**DOMINION NUCLEAR CONNECTICUT, INC.**  
**MILLSTONE POWER STATION UNIT 3**  
**RELIEF REQUEST IR-3-05 RESPONSE TO REQUEST FOR ADDITIONAL**  
**INFORMATION REGARDING PROPOSED ALTERNATIVE RELATED TO**  
**INSERVICE INSPECTION OF WELD OVERLAYS FOR THE THIRD 10-YEAR**  
**INTERVAL**

**RELIEF REQUEST IR-3-05**  
**RESPONSE TO REQUEST FOR ADDITIONAL INFORMATION REGARDING**  
**PROPOSED ALTERNATIVE RELATED TO INSERVICE INSPECTION OF WELD**  
**OVERLAYS FOR THE THIRD 10-YEAR INTERVAL**

**10 CFR 50.55a Request Number IR-3-05  
Revision 1**

Fig. 1(a): Examination Volume in Full Structural Weld Overlays

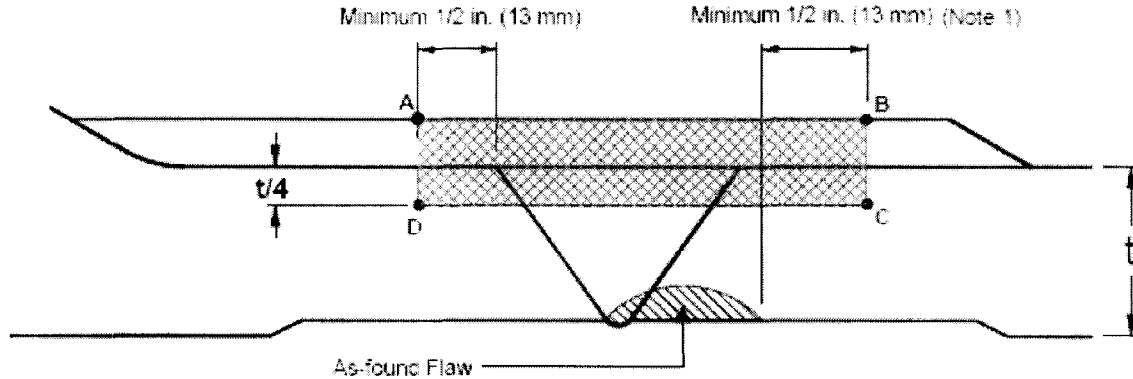
The ASME Task Group on Alloy 600 and the NRC staff are in agreement that the appropriate dimensions for Figure 2(b) from ASME Code Case N-770, which is utilized in IR-3-05 as Figure 1(b), shall be equivalent to the nominal thickness of the nozzle end preparation or the pipe being overlaid, as appropriate. Please meet the dimensions described above or provide justification for the current dimensions.

occurred after the initial submittal of IR-3-05, has not yet been published. In it, TGA600 revised Figures 2(a) and 2(b). DNC agrees to incorporate the revised figures into IR-3-05, Rev. 1 as Figures 1(a) and 1(b), respectively.
